Fleurie Nursery , Lake Lane.
Response to ADC Engineer questions.

For reference block names are as per drawing attached and abbreviations as shown in parenthesis are used throughout - southern tunnels (ST), southern glass (SG), eastern glass (E), northern (N).

A drawing of the sump is attached in Annex 2.

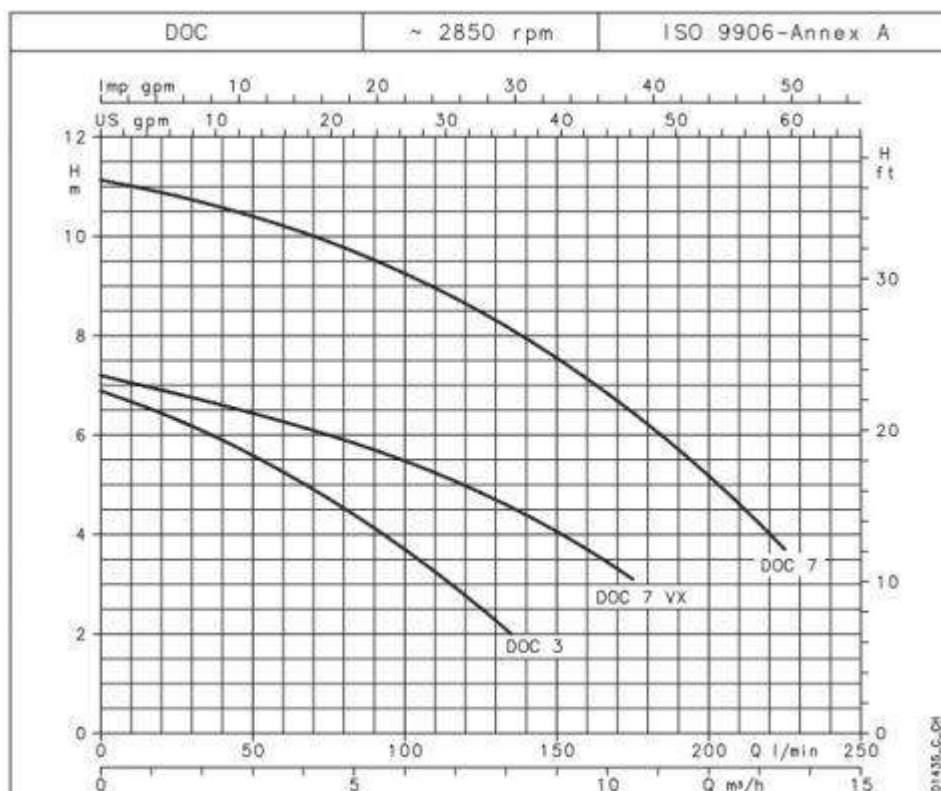
4. Scheme details - sump / pump

This system is very simply used to reduce the amount of time that the drainage system sits flooded, it is not a part of the actual means that water gets from the greenhouses to the attenuation tanks nor a means of emptying the tanks. After a rainfall event a flooded pipe system will sit with water in it up to a height of the outlet into the tank, unless a drain down pump is fitted. This pump simply drains down this water in the pipe so that it is not continuously sitting flooded. The discharge from the pump is into the tank, so nil effect on system capacity or discharge. If it fails it will have no impact on the system capacity.

Pump make and model: Lowara DOC3.

The drain down pump (sump pump) discharge is into the tank adjacent to it, there is no direct discharge from the pump to a water course. See Annexe 2.

Annexe 1. Upper Orifice Plate discharges and tank fill depths.

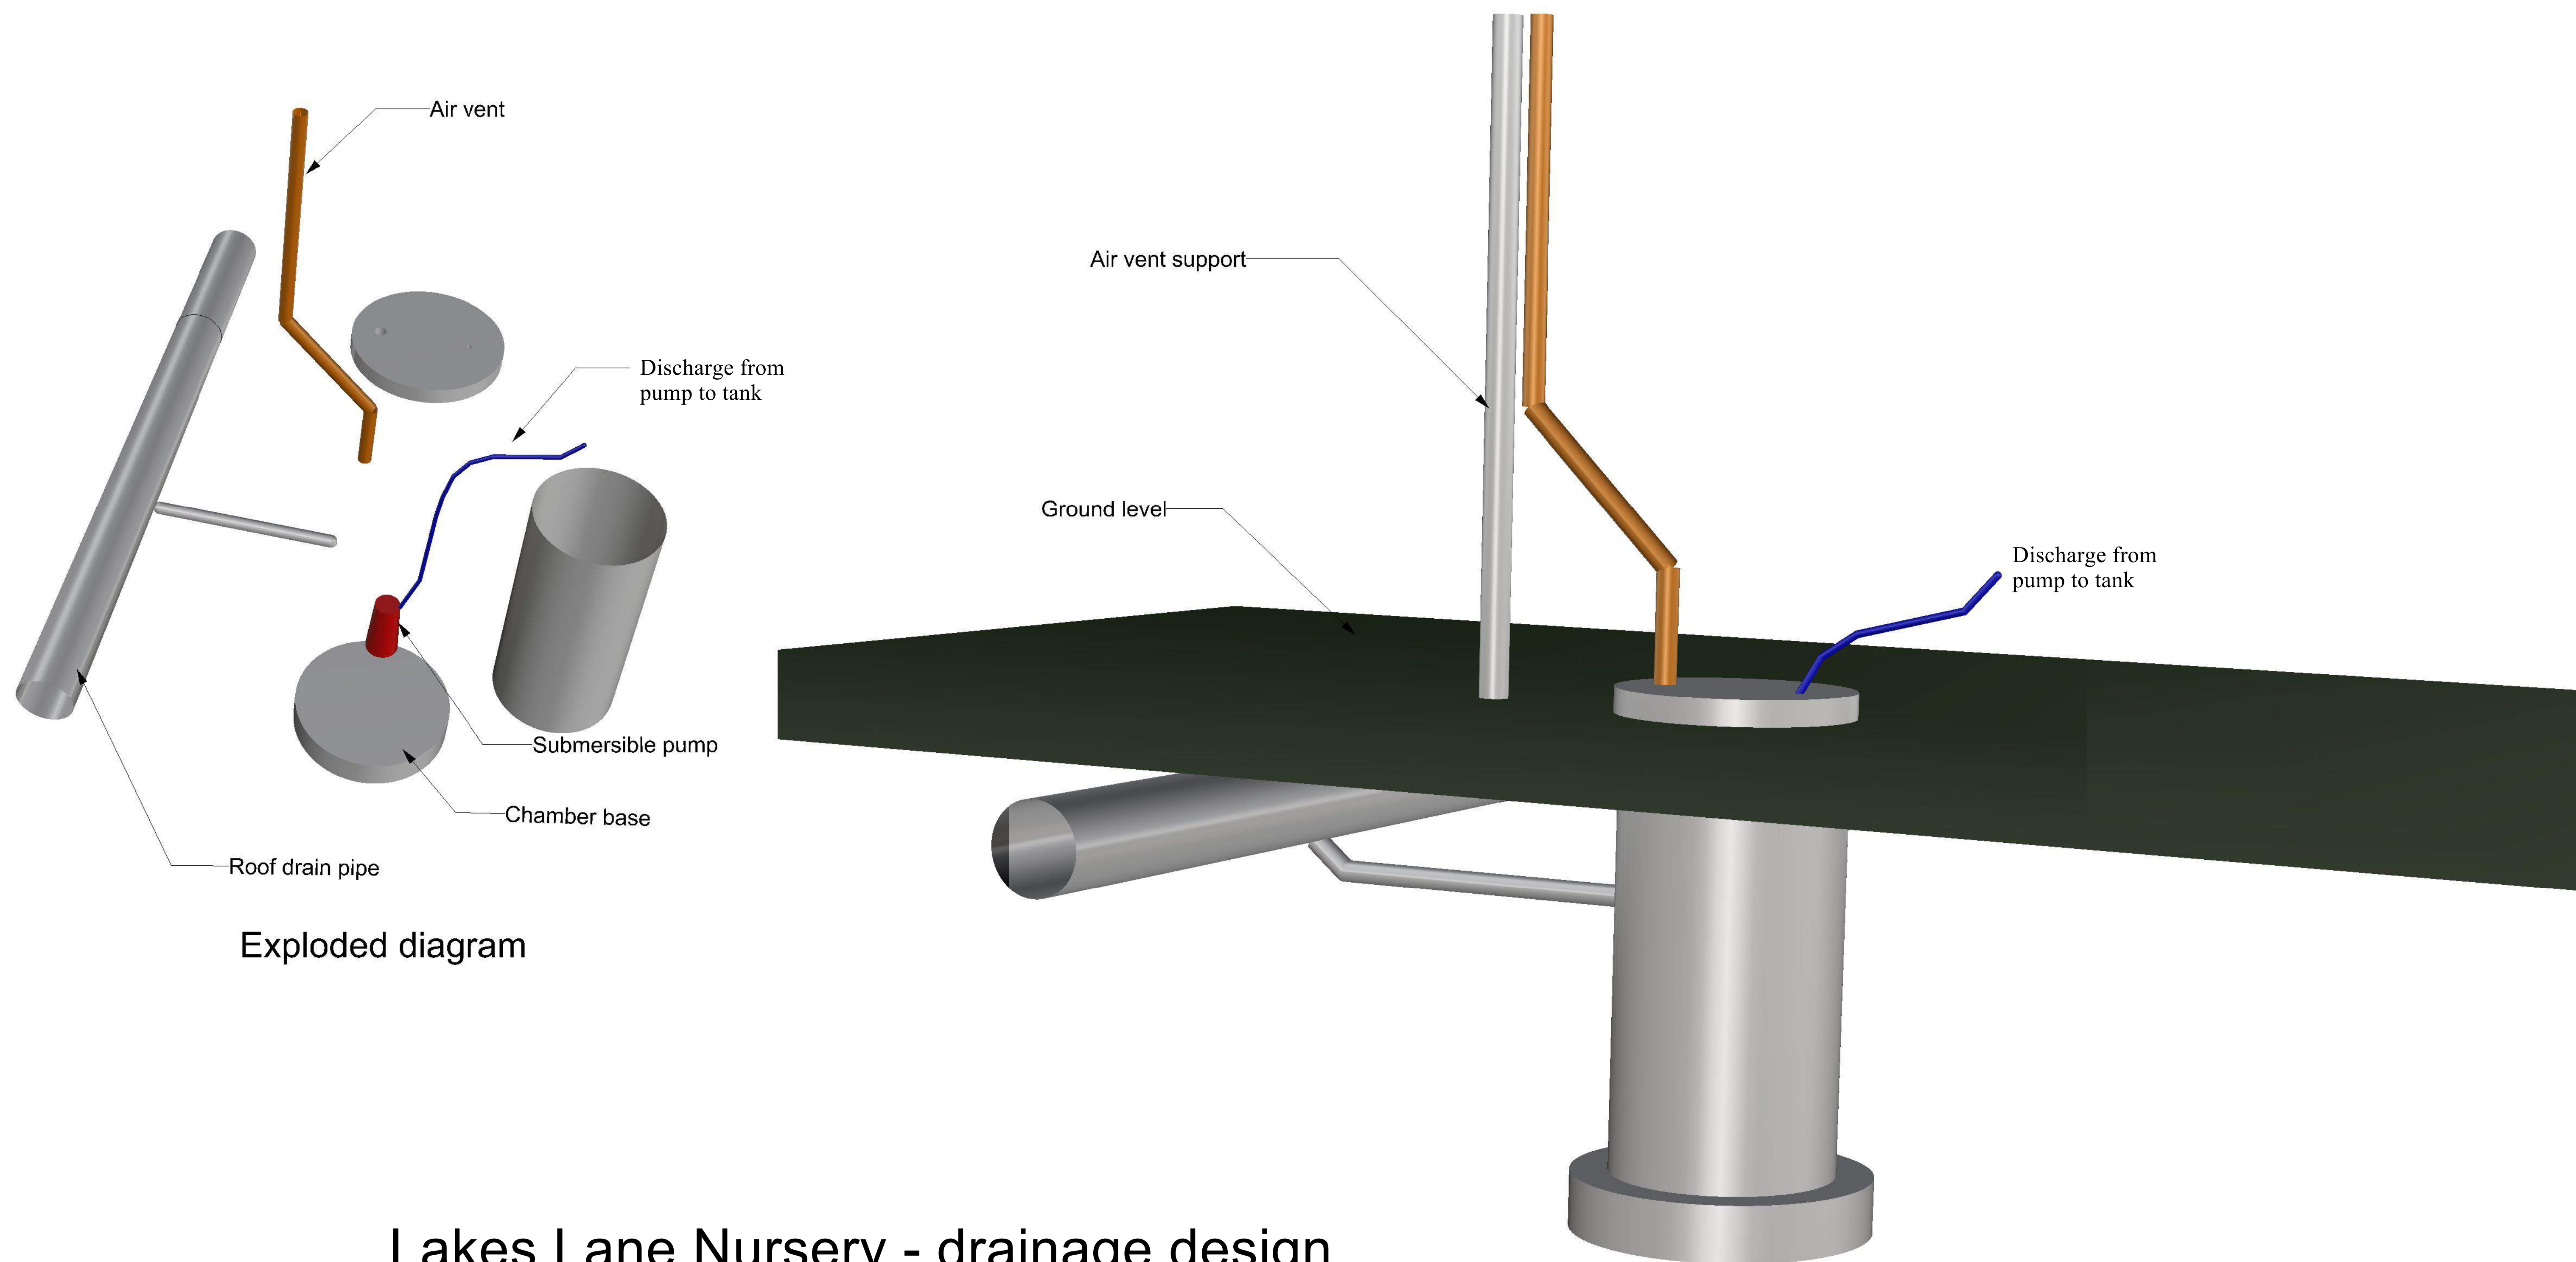
2a. Storage volumes, orifice plate heights and water levels.

See Annexe 1 for tables showing the discharge from the Upper Orifice Plates (UOP) according to return period, and the height of water in the tanks (to show no exceedance under these conditions).

The tables below are for the 4 areas, calculated for the 1, 10, 25, 30 and 100 year return periods, and for the 1 minute to 35 day site specific Met Office data, with 40% CCA added.
